## HISTORIC AND DESIGN REVIEW COMMISSION

October 17, 2018

**HDRC CASE NO:** 2018-511  
**ADDRESS:** 636 MISSION ST  
**LEGAL DESCRIPTION:** NCB 2913 BLK 2 LOT 10 S 5 FT OF 9  
**ZONING:** RM-4, H  
**CITY COUNCIL DIST.:** 1  
**DISTRICT:** King William Historic District  
**APPLICANT:** Jeffrey Szarek  
**OWNER:** Jeffrey Szarek  
**TYPE OF WORK:** Fenestration modifications to a rear addition; window and door removal  
**APPLICATION RECEIVED:** September 28, 2018  
**60-DAY REVIEW:** November 27, 2018  
**REQUEST:**

The applicant is requesting a Certificate of Appropriateness for approval to perform exterior modifications to a rear addition at 636 Mission including the removal of five (5) windows on the rear (east) façade, one (1) window on the south façade and the removal of one door on the south façade. Within the proposed fenestration modifications, existing windows will be relocated from their original locations.

636 MISSION ST.  
LAUNDRY + MASTER BATHROOM ELEVATIONS

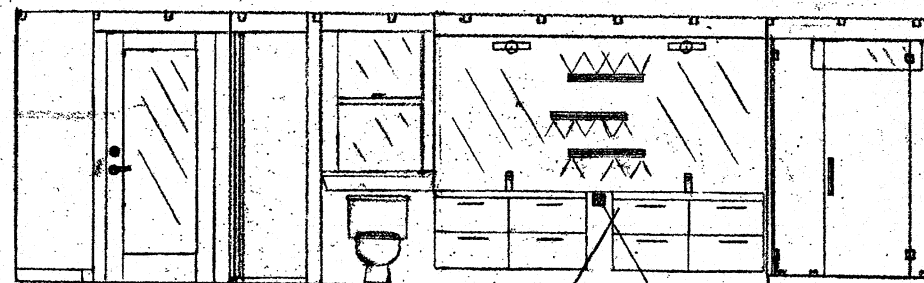
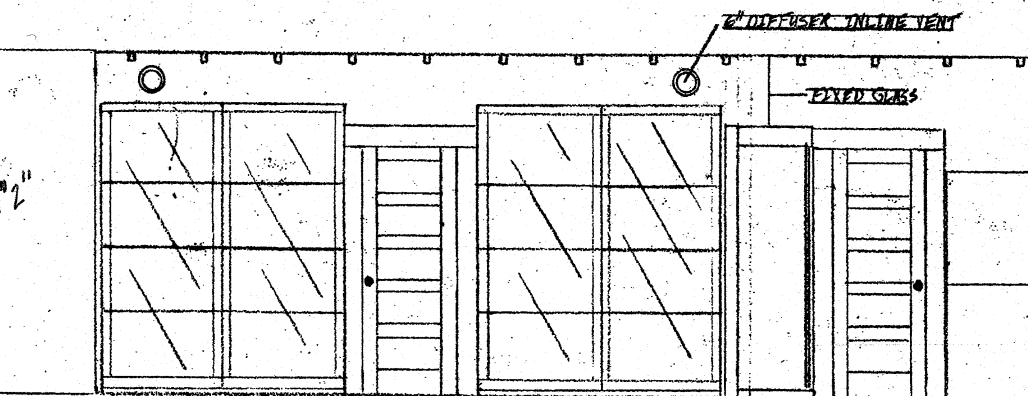
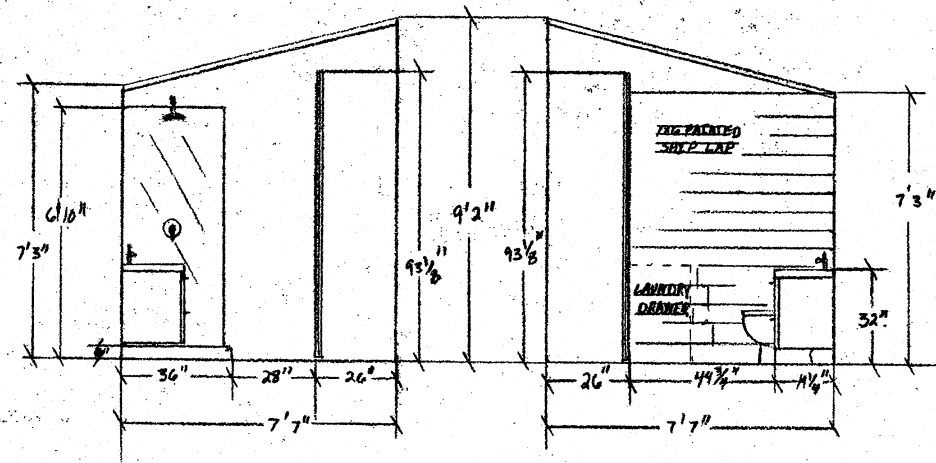
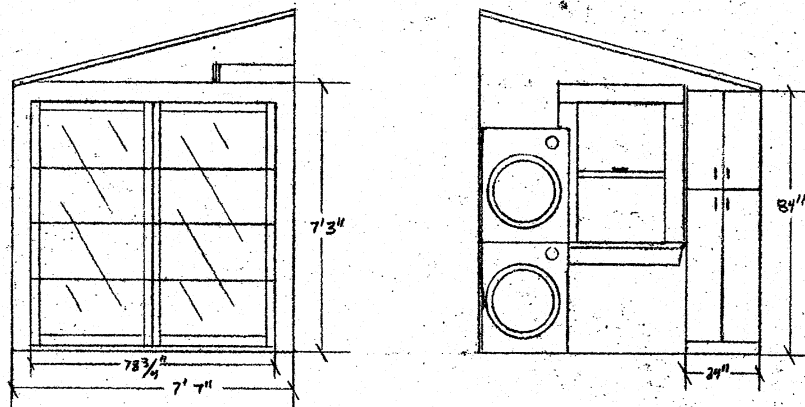
- b. **EXTERIOR MODIFICATIONS** – The applicant has proposed exterior and fenestration modifications that include the removal of five (5) windows on the rear (east) façade, one (1) window on the south façade and the removal of one door on the south façade. Within the proposed fenestration modifications, existing windows will be relocated from their original locations. Per the Guidelines for Exterior Maintenance and Alterations 7.B.ii., original architectural details should not be obscured by any screening or enclosure materials. Alterations to side and rear porches should result in a space that functions, and is visually interpreted as, a porch. Staff finds the proposed removal of windows inappropriate as it would remove character defining features of the existing, enclosed porch.

Staff does not recommend approval based on findings a and b.
